AMENDMENT: Page 4 of 21 S/N 09/519,719 4150/ETCH/DRIE/JB1

REMARKS

This reply is intended as a full and complete response to the Office Action mailed on October 11, 2001. In view of both the amendments presented above and the following discussion, the Applicants believe that all claims are now in allowable form.

FIG. 2B

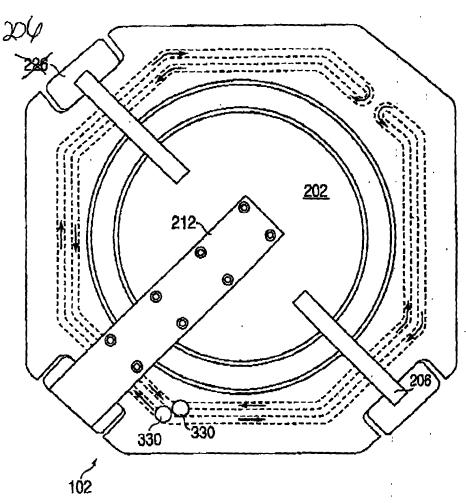
The drawings stand rejected for various reasons. In response, the Applicants have provided red-lined corrections to Figs. 1, 2B, 3 and 6.

Specifically, the Applicants have deleted reference numerals 126, 128, 130, 131, 148, 150, 151, 152, 188, 604 and 606 from Figs. 1 and 6. Reference numeral 226 has been replaced with 206 in Fig. 2B. Reference numeral 350 has been replaced with 350A in Fig. 3. Fig. 3 has also been amended to add the reference numeral 310 as described in the application at pages 7 and 8. Fig. 1 has been amended to distinguish liners 118 and 134 as separate elements. Additionally, the leader of reference numeral 122 in Fig. 1 has been extended to reference the o-ring as required by the Examiner.

Corrected formal drawings are enclosed in anticipation of the Examiner's approval of the submitted red-lined corrections Figs. 1, 2B, 3 and 6.
